Minutes

SMP Coastal Panel Meeting 12: Coastal Adaptation Plans

Review and sign-off of draft Coastal Adaptation Plans for submission to the SMP Committee of Council and public consultation.

PU22 - Manaia

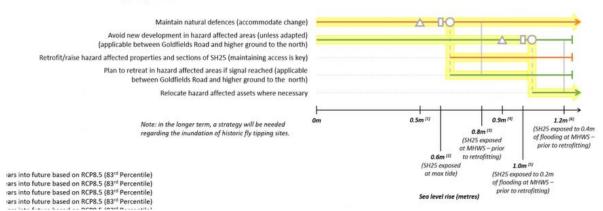
DC – there is an issue with land level rise on this side of the peninsula AM – will be a change in terminology to 'relative' SLR which considers the land either raising or subsiding, but triggers remain the same (just may get to them later or sooner)

PU26 - Te Koumu to Preece

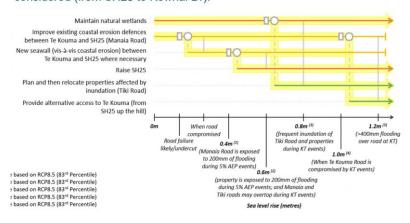
SJ – in southern parts there are immediate issues with erosion, other areas have medium – long term issues with inundation

KJ – should say Te Kouma rd. rather than Manaia Rd

AM – what are the priorities here? E.g. short-term defences, long term – alternative route

PU29 - Wharf Rd (and McGregors)

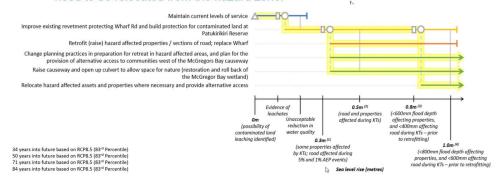
SJ – possibility to bridge the stretch of road rather than find an alternative route

MD – if the water goes over the wetland more, it will be estuary rather than wetland.

AM – if road is raised it might compromise the wetland from re-establishing. Pathway needs to be made clear that raising the road is not protection for the land owners, rather to protect access

SJ – do we need to replace the Wharf?

PU68 + 69 - Kennedy Bay

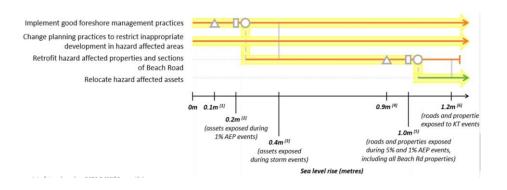
SJ – remove "is cohesive and' from strategy statement

JA – are they talking about a new development in a hazard effected area?

- KJ is there a definition on what 'restrict' or 'avoid' development means?
- SJ needs to be written up
- SJ needs to be more discussion on the urupa's as community disagree that the visible one's are not at risk. They are also aware of other urupa that are not visible.

JA – suggests what they are talking about is outside of the 'scope'. TCDC have talked to people/experts about this, and panels are restricted to recommending within the 'scope'. Maybe change the language as we need to report what has been done so far. Make it clear we are 'reporting' on what we have found and discussed within the coastal panels' scope. AM – maybe add, further community feedback is needed before finalising the implementation.
